Sydney Olympic Park - Site 13 Preferred Project Report - February 2010

Preferred Project Report February 2010 S10849

Preferred Project Report February 2010 S10849

Site 13 Sydney Olympic Park 3.0 Revised Plans 3.ii. Ground Floor Plan (L00)

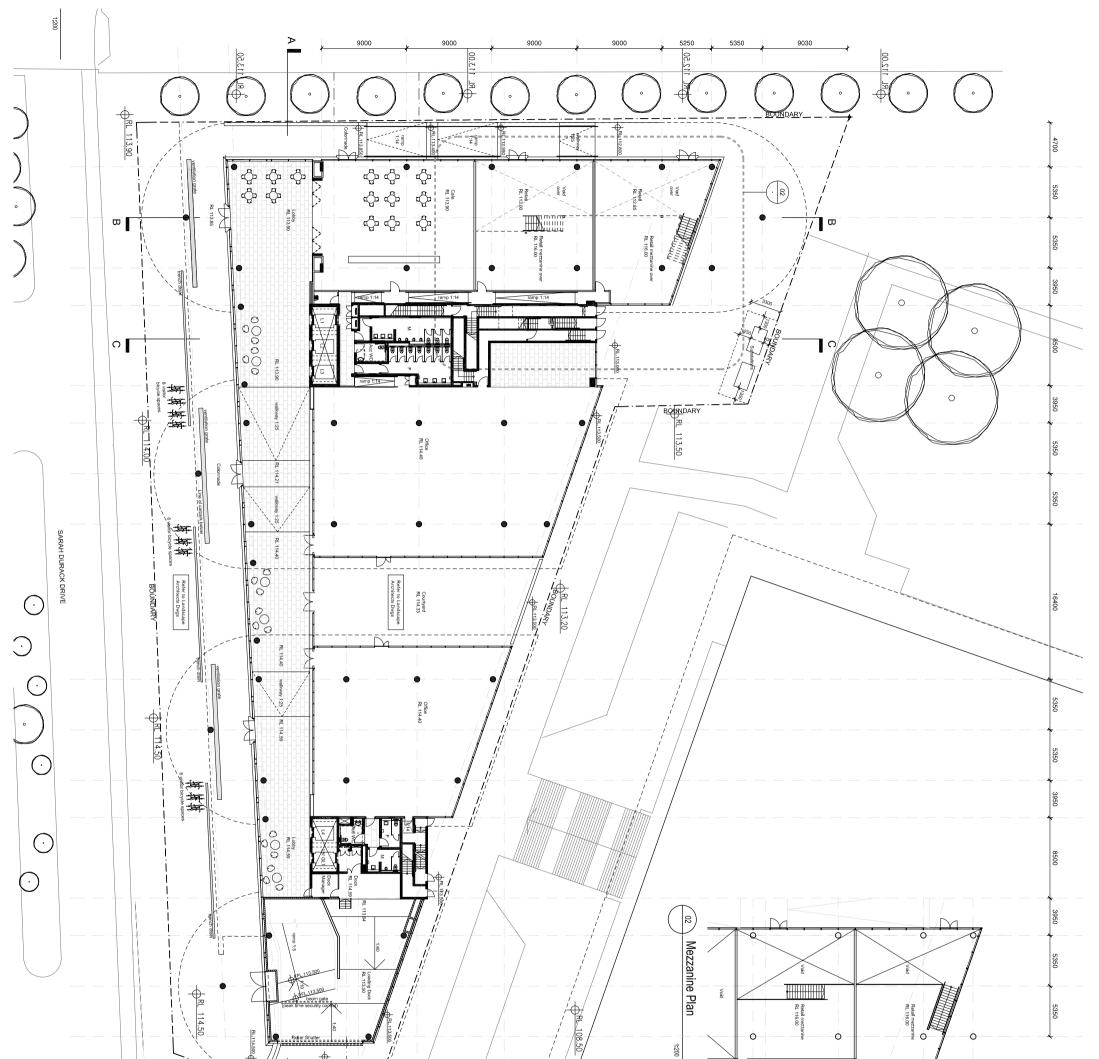
2.0	Ground Floor	Refer to drawing: AR-EA-2.03
		2.01 Level changes in office tenancies, retail areas and courtyard
		2.02 Retail service corridor introduced

2.03 Core building A amended to fit additional fire corridors and fire exits
		2.04 Ramp between office tenancy and core building A introduced
		2.05 Substation configuration amended

2.06 Café tenancy relocated and café entry from foyer introduced
		2.07 Split retail tenancies (2 instead of 1)
		2.08 Mezzanine Level introduced over retail tenancies

2.09 Set out of ramps within building foyer amended
		2.10 Dock manager room relocated
		2.11 Visitor bicycle spaces introduced on ground floor (20 no.)

2.12 Security swipe card readers introduced for vehicle entry into the basement carpark
		2.13 Security boomgate introduced inside carpark roller shutter for peak time control

2.14 Substation kiosks relocated to align with southern boundary and lowered by 400mm
		2.15 Landscaped ramp at the south of Core A widened to full width of path

2.16 Stairs removed to colonnade adjacent to café on Olympic Boulevard and replaced with ramps at 1:14 gradient
3.0	Typical Level	Refer to drawings: AR-EA-2.04, AR-EA-5.01 to 5.04, AR-EA-7.01, AR-EA-7.11

Site 13 Sydney Olympic Park 3.0 Revised Plans 3.iii. Typical Floor Plan (L01-L03)

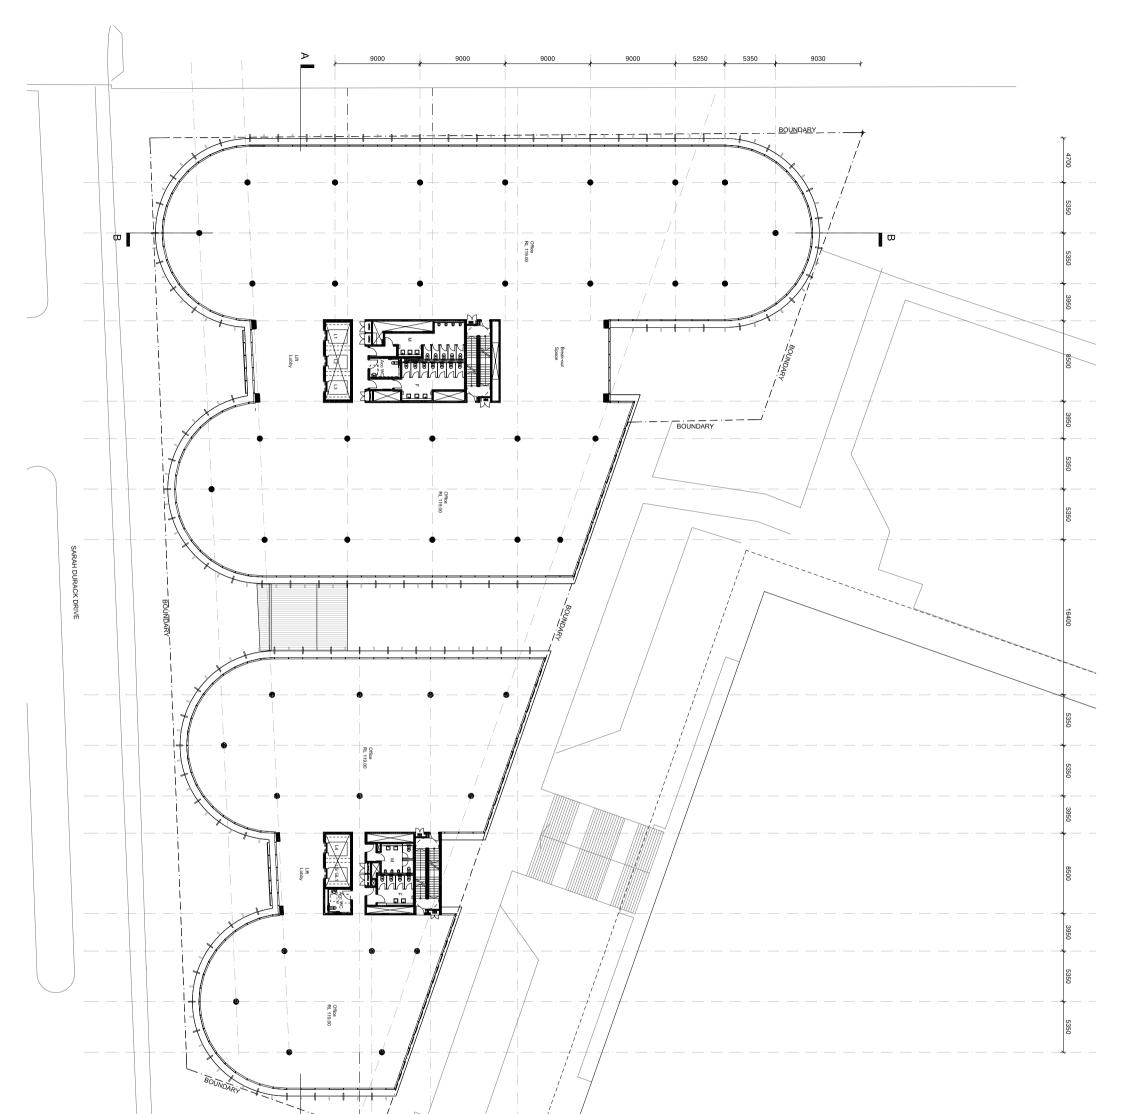
3.01 Reduced size of vertical aluminium fins (sunshades)
		3.02 Deleted internal partition walls between office floor plates and naturally
		ventilated spaces 3.03 Deleted ventilation shafts

3.04 Reduced projection beyond site boundary (slabs within the boundary, sunshades protrude 400mm over the boundary)
		3.05 Amended layout of shafts and bathrooms in building A + B cores

3.06 Façade details have been developed beyond the state of documentation in DA report sketches
		3.07 Floor finish to lift lobbies and break out amended

3.08 Replacement of black anodised aluminium cladding to projecting slab edges by aluminium cladding coated in black PVF2
		3.09 Replacement of clear glass on ground floor by clear performance glass

3.10 Projection of clad concrete slab beyond the southern boundary by 300mm
		(glass façade remains inside of he boundary)
		3.11 Finish to southern wall of core B changed from off-form concrete to painted
